RUTH M. HAVEY · *Landscape Architect* ❀ TWENTY-FIVE FIFTH AVENUE · NEW YORK 3, N.Y.

DUMBARTON OAKS AGENDA---August 2, 1949

ARBOR GARDEN---

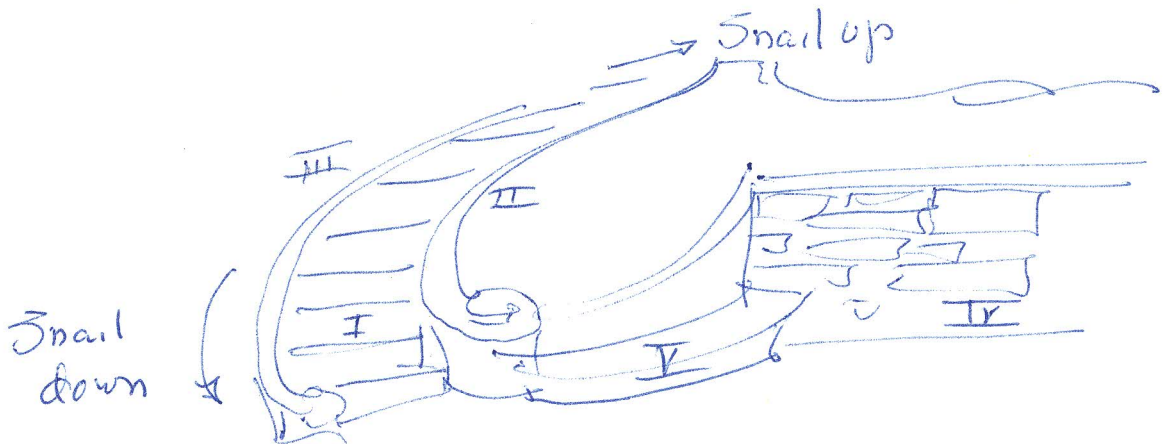
Sketch two panels in arbor wall without lead lotus and
bullrushes---leave waves.
